Process Sheet

Customer : CU-DAR001 Dart Helicopters Services
 Job Number : 32661-3
 Estimate Number : 12811
 Proj. Number :
 Job Issue : 5/25/2007 S.O. No. :
 Last Rev. : NC
 First Issue : // Type : SMALL /MED FAB
 Previous Run : 32003
 Written By :
 Checked & Approved By :
 Department : Est Rev/A New Issue 07-03.26 ec

Drawing Name : BRACKET
 Part Number : D35921
 Drawing Number : D3592 REV A
 Project Number : N/A
 Drawing Revision : REV A
 Material :
 Due Date : 6/10/2007
 Qty: 125 Um: Each

**D3592-1 PLATE**

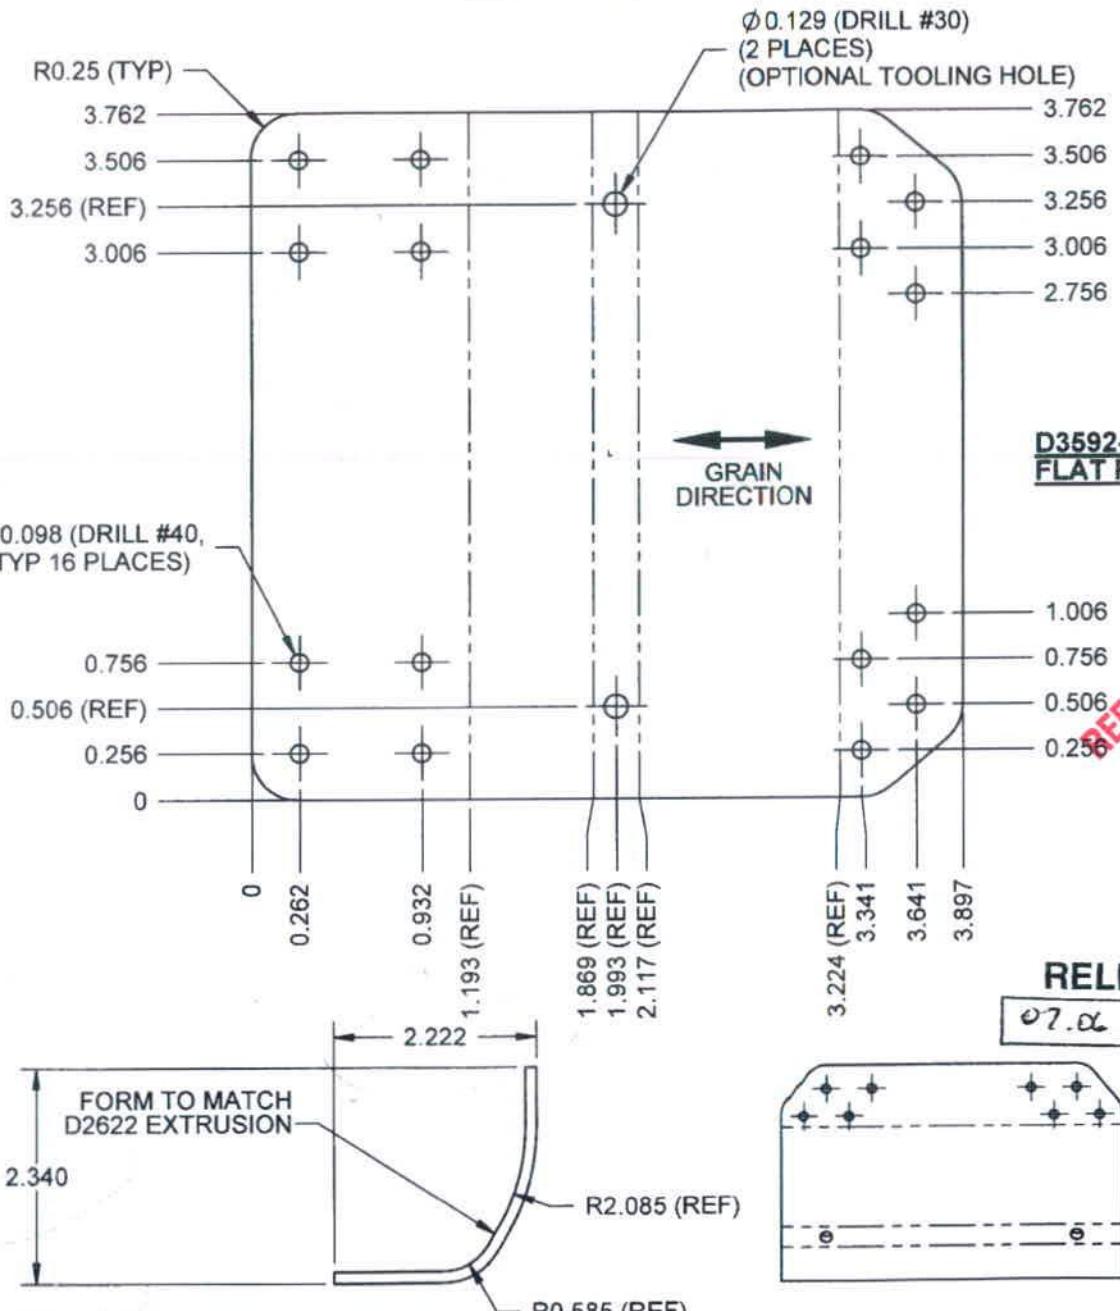
DATE	STEP	PROCEDURE CHANGE	By	Date	Qty	Approval Chief Eng / Prod Mgr	Approval QC Inspector
07/06/05	2	REPROGRAM TO REL.5 TO ADD TOOLING HOLES. SIZE ATTACHED AS EMAIL FOR OK ON TOOLING HOLES				<i>GP</i> <i>P.R.</i> <i>07/06/05</i> <i>07/06/05</i>	
07/06/05	5	Split w/o	8K	07/06/05	85	<i>J</i>	<i>J</i>
07/06/05	5	Split w/o	SP	07/06/12	42	<i>07/06/12</i>	<i>07/06/12</i>

DATE	STEP	Description of NC Section A	Corrective Action Section B			Verification Section C	Approval Chief Eng	Approval QC Inspector
			Initial Chief Eng	Action Description Chief Eng	Sign & Date			
07/06/04	2.0	125 parts scrup. Parts needed extra holes for the bending tool.	<i>GP</i> 07/06/04 P.R. 05/04/04	SCRUP parts, and replace to Rev. B, under Preliminary Issue. See E-mail	<i>ML</i> 01/06/04 07/06/03	<i>J</i>	<i>GP</i> 07/06/04 P.R. 05/04/04	<i>J</i>
				SCRUP: destroy parts	<i>SP</i> 07/06/04 07/06/04

DESIGN <i>QP</i>	DRAWN BY <i>JL</i>	DART AEROSPACE LTD HAWKESBURY, ONTARIO, CANADA	
CHECKED <i>QP</i>	APPROVED <i>TH</i>	DRAWING NO. D3592	REV. B SHEET 1 OF 1
DATE 07.05.31		TITLE PLATE	SCALE 1:1
A	07.01.15	NEW ISSUE	
B	07.05.31	TOOLING HOLES ADDED
